Proposed Site Plan
Scale 1 : 200

Project:	Station works				
	Bury Road, Radcliffe, M26 2UA				
Title:	Proposed Site Plan				
Client:	Paul Cook Developments/ Jigsaw Homes				
Drawn By:	NM	Checked By:	TR	on	03.08.23
Original Size:	A1	Project Number:	22049		
Drawing Number:	SI-00-DR-A-1001				REV Q

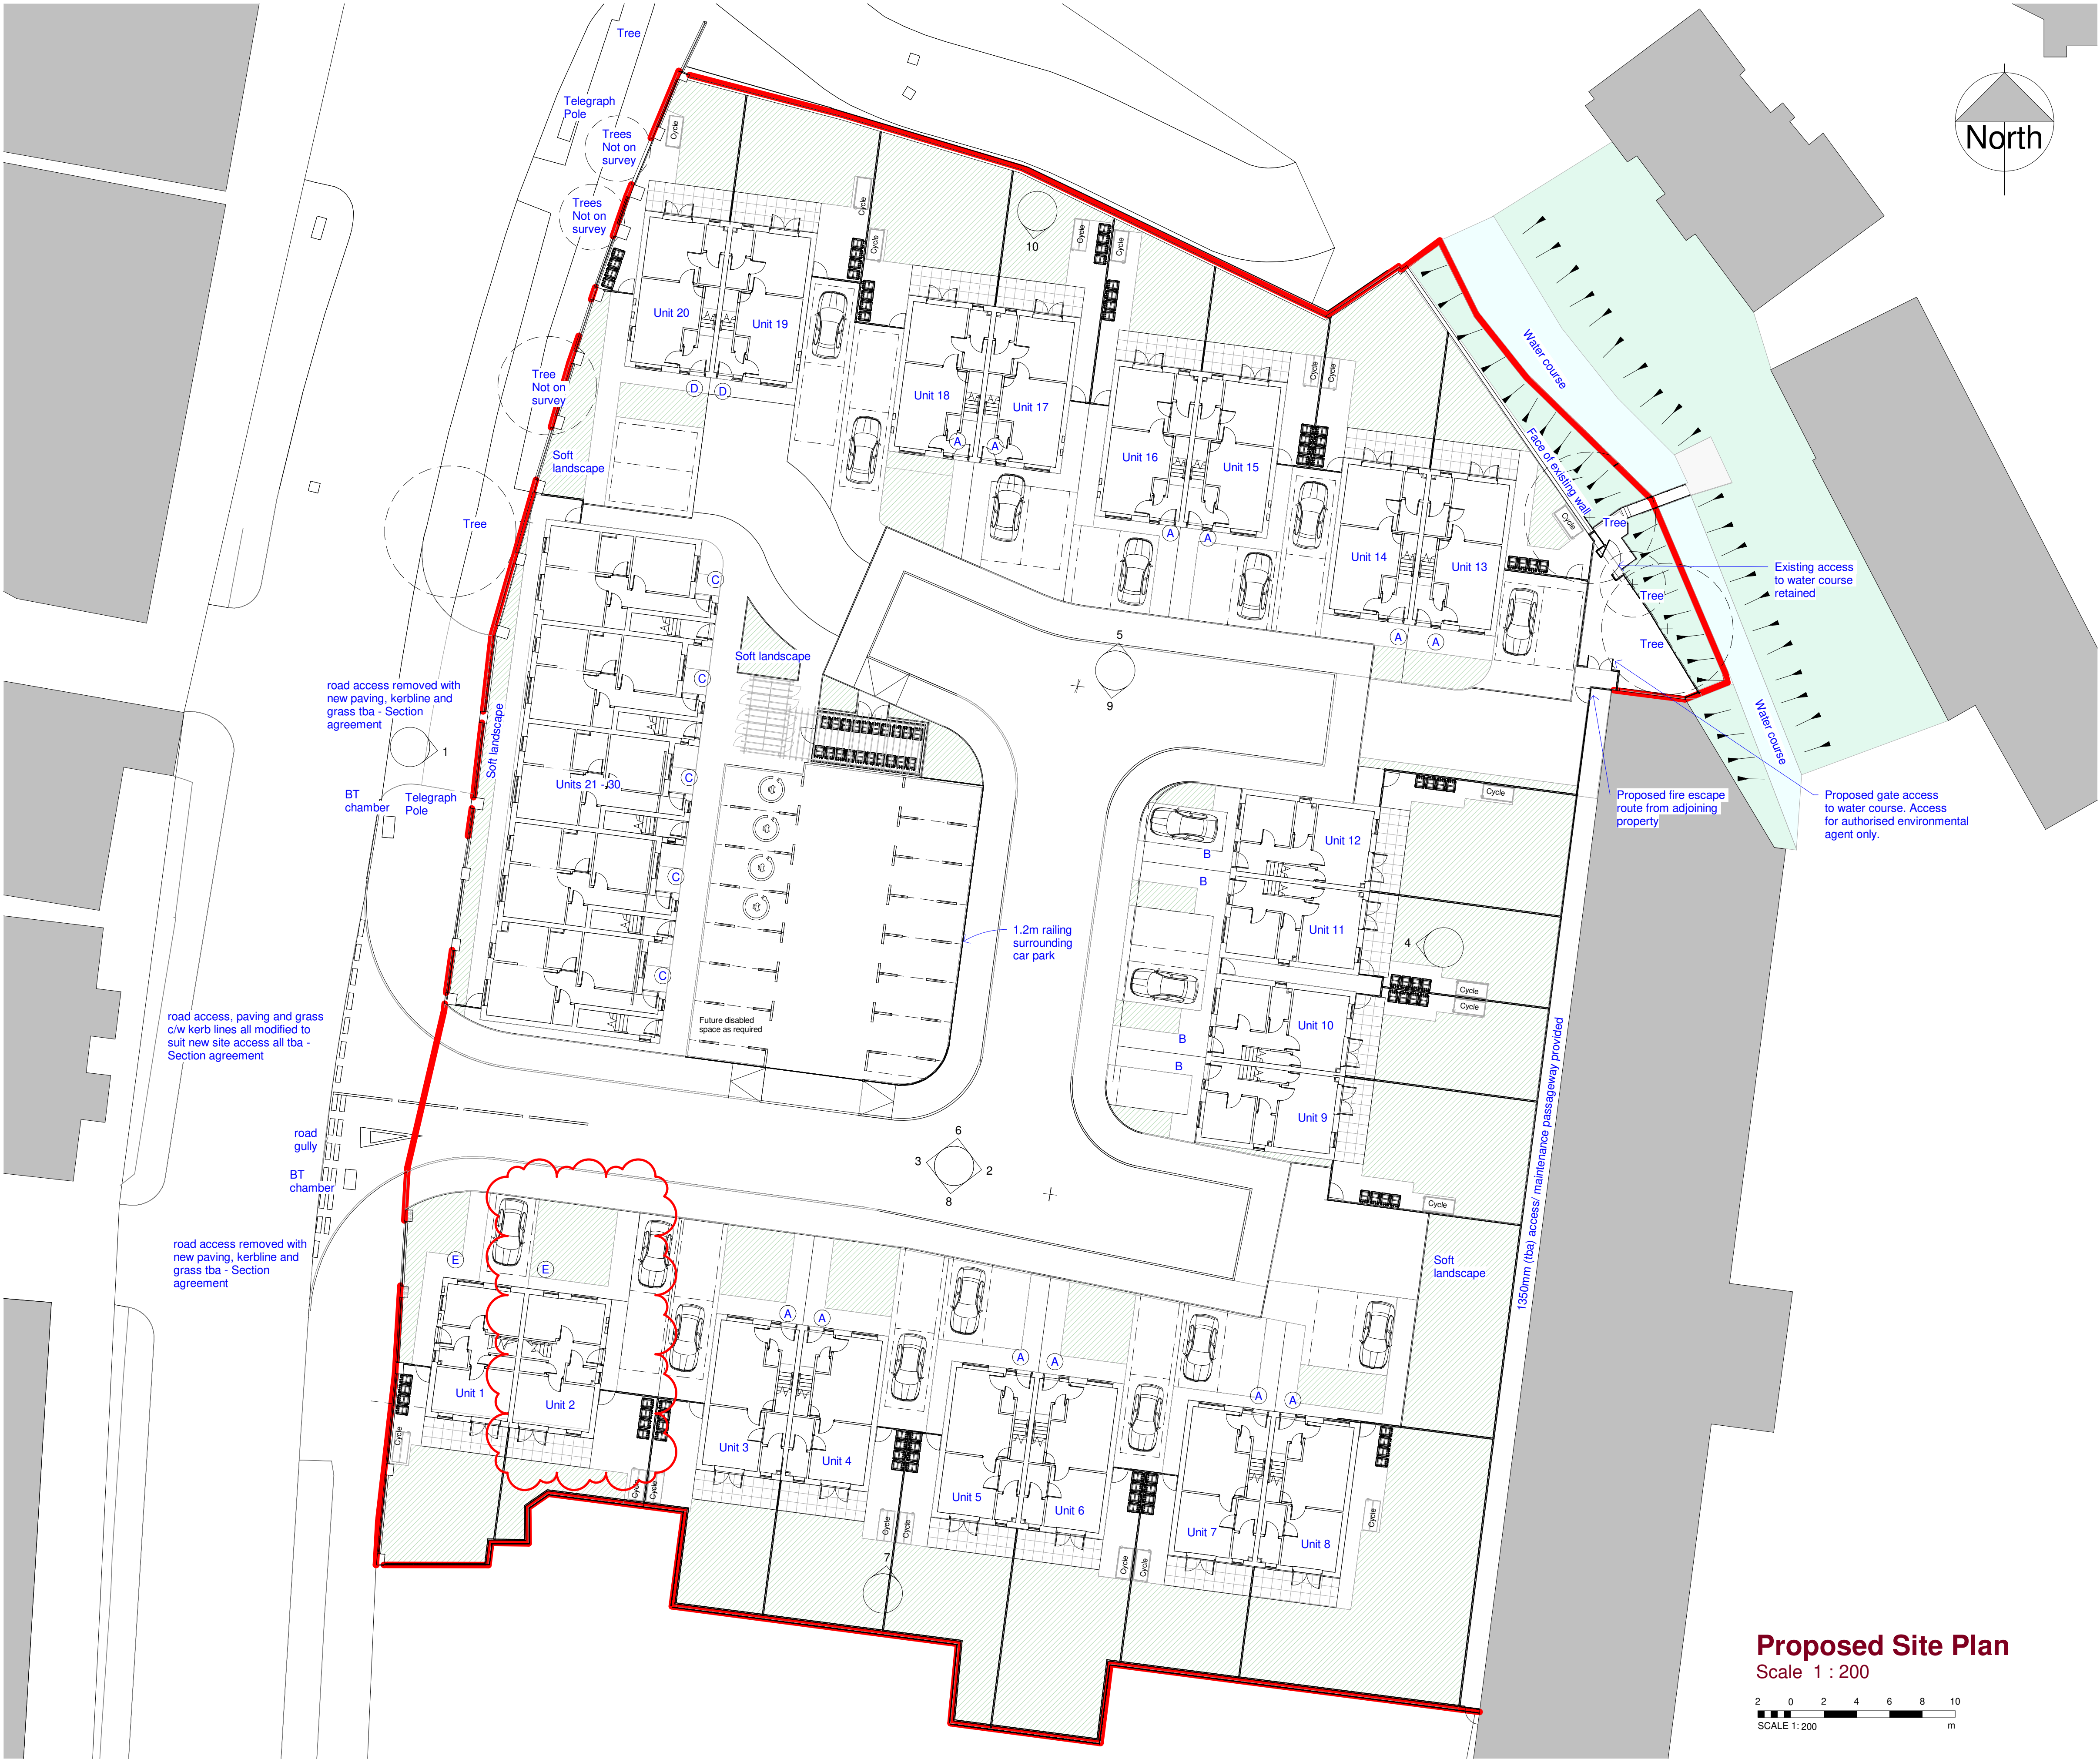
Q	Unit 2 layout changed to match Unit 1 in response to planners' comments dated 02.08.23.	AL	TR	03.08.23
P	Existing brook access revised in response to GMEU's comment. Units 3-8 & 15-18 repositioned to maximise the distance between rear of building to face of fencing. Dropped crossing to bin store added.	AL	TR	04.07.23
N	Shared driveway increased to provide turning area.	CM	TR	06.06.23
M	Shared drive width reduced to 4.8m in response to comments received from the Planning Officer	CM	TR	05.06.23
L	Patio and lawn adjusted to suit house Type A and D revised length.	AL	TR	10.03.23
Rev	Description	By	Chk	Date
